**SUBJECT: First Capitol Drive  
TAP 7302(661)  
Bid # 4226  
Addendum #2**

# Roadway Enhancement Project First Capitol Drive TAP-7302(661) Proposal

PROJECT NAME:	
FIRST CAPITOL ENHANCEMENTS	
PROJECT NO.: 15-16537	DATE: 12/09/2016

## SUMMARY OF QUANTITIES

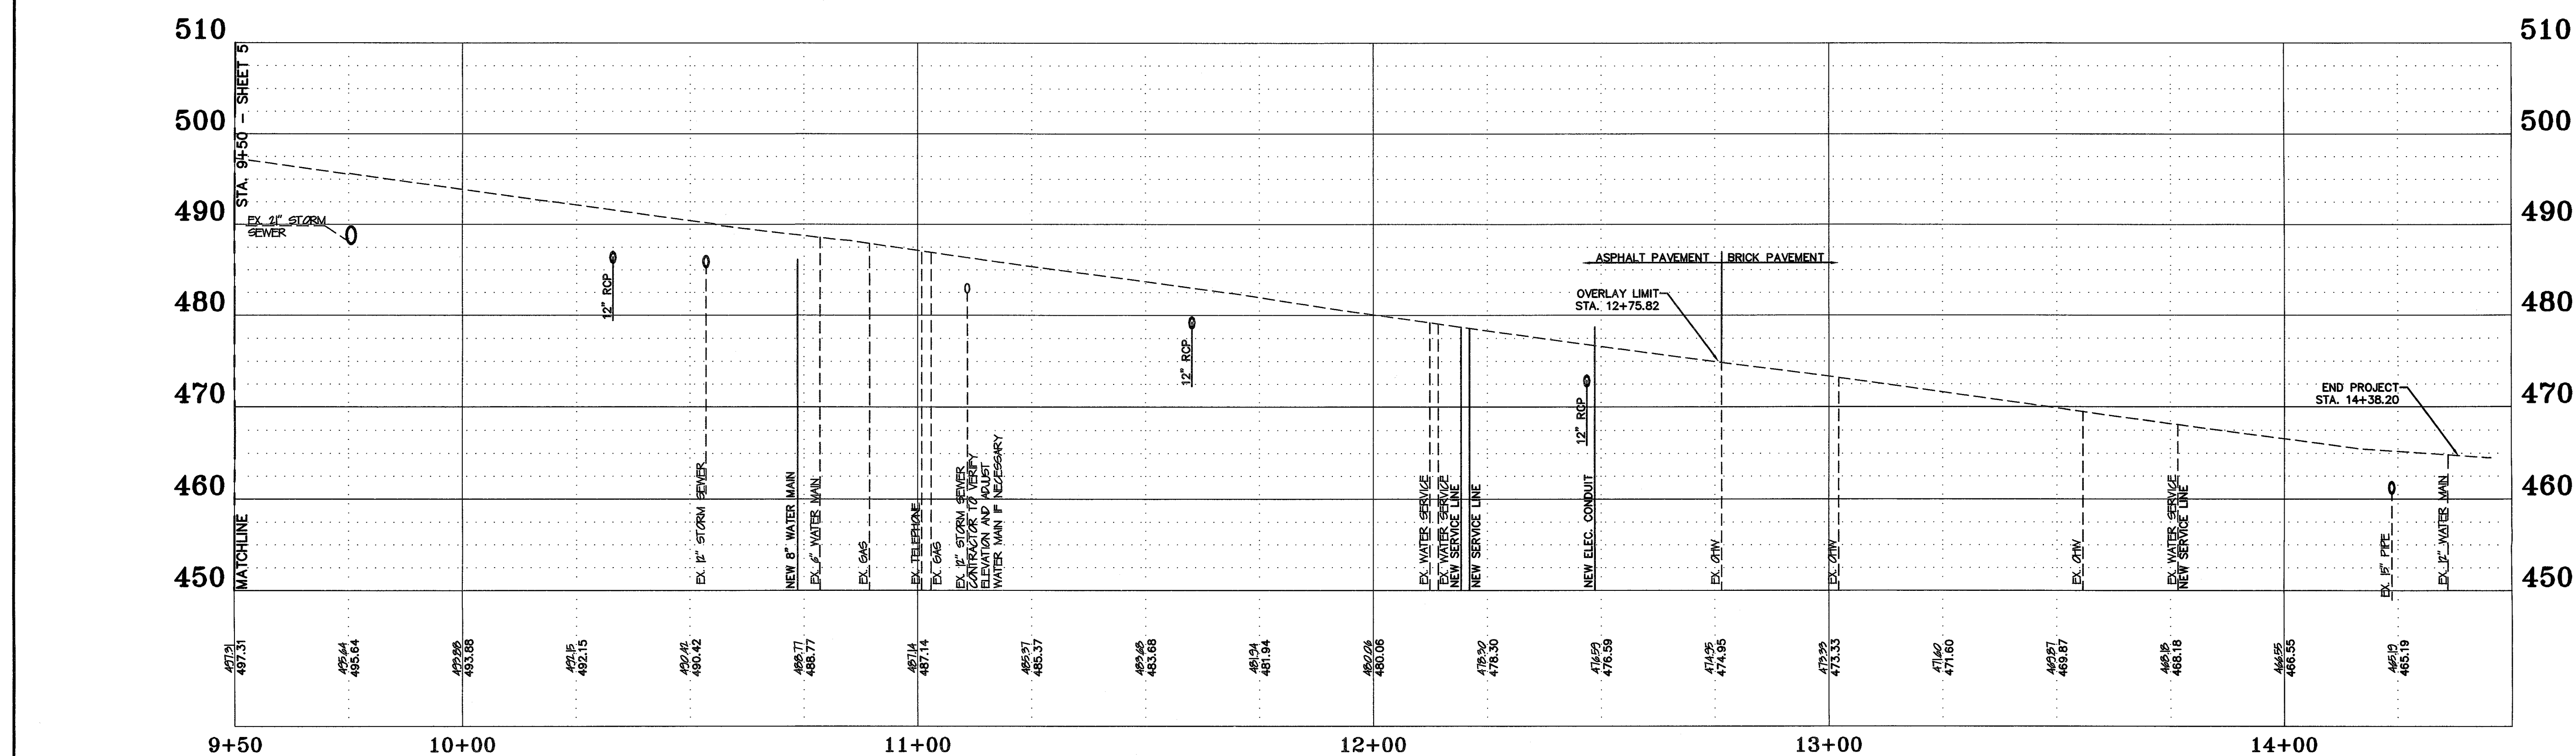
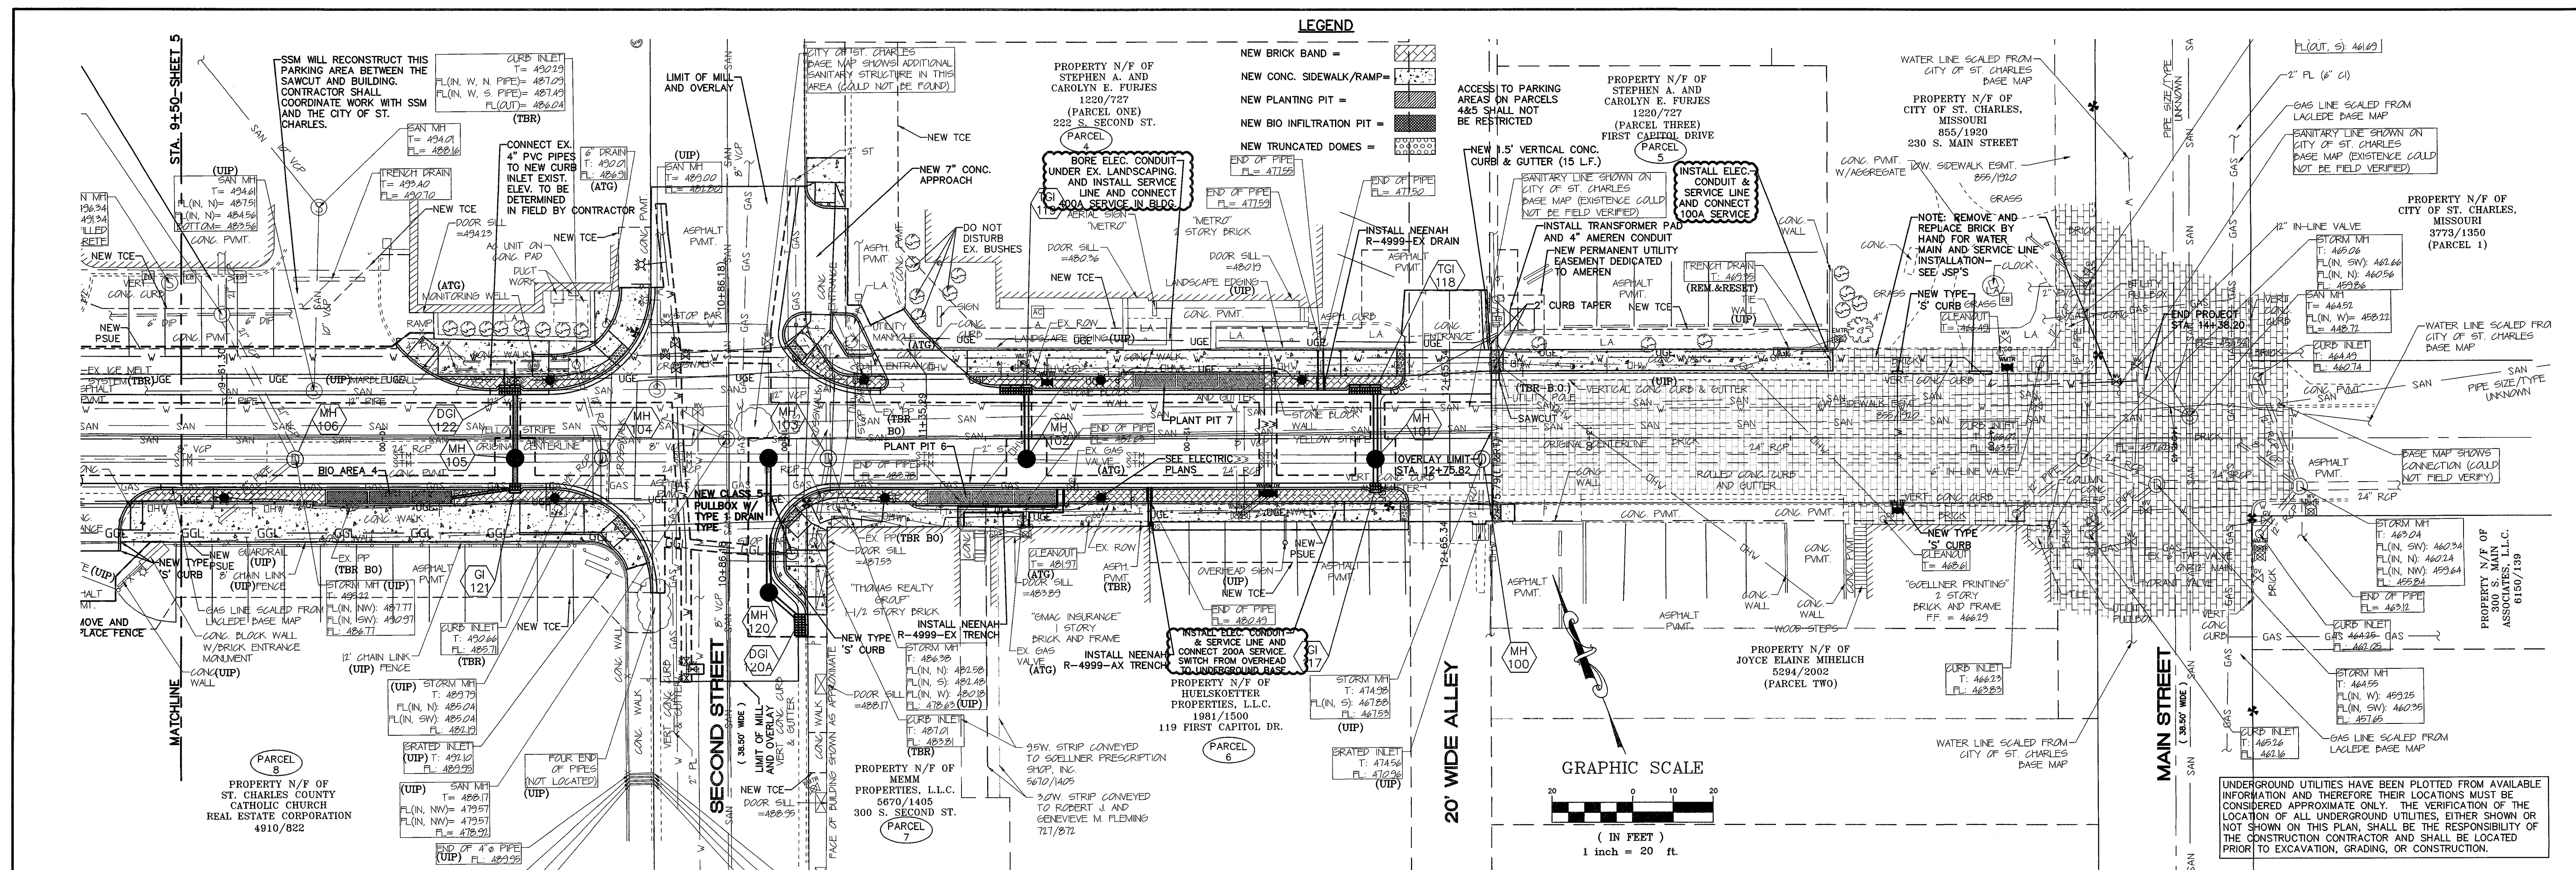
REVISIONS	
DATE	BY	DESCRIPTION	DATE	BY	DESCRIPTION
01/30/17	JBS	AGENCY COMMENTS			
3/21/17	JBS	BID SET			
4/11/17	JBS	REVISE ELECTRIC CONDUIT AND SERVICE CALLOUTS
